U.S. Department of Energy

Subject: June 13, 2002, Visit to the Church Rock, New Mexico, UMTRCA Title II Site

June 13, 2002, Visit to the Church Rock, New Mexico, UMTRCA Title II Site

Figure 4

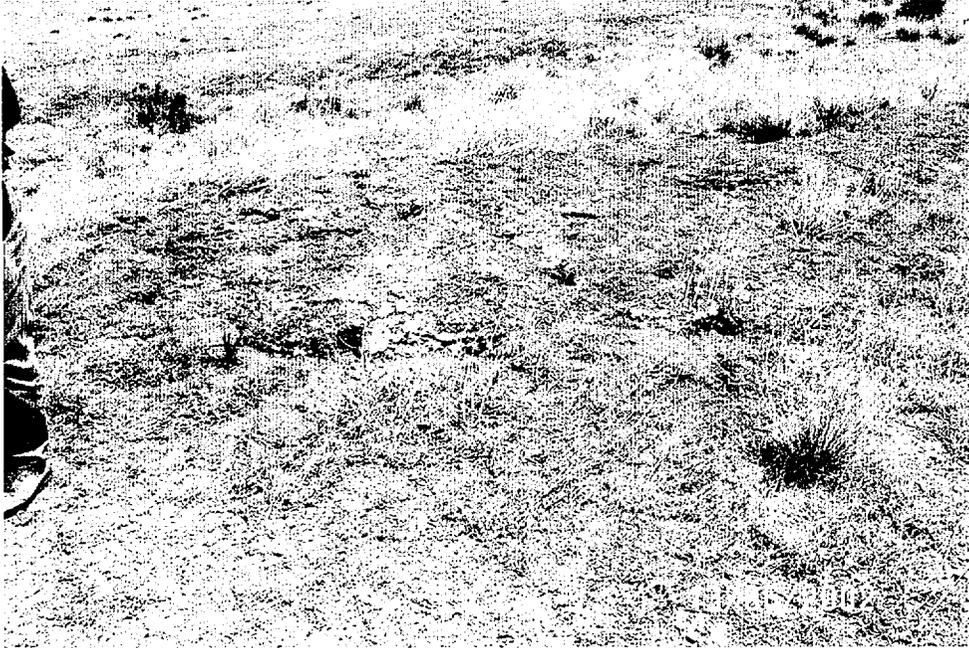
Bioinvasion of the cell cover was visible. Deep rooted plants such as tamarisk and rabbit are rooting in the radon barrier and likely in the tailings, Figure 4. Gophers have made burrows in the cover soil but probably have not penetrated the 3-inch thick layer of riprap, Figure 5. Prairie dogs are present in the area according to Mr. Bush but no evidence of them was seen on the cell.
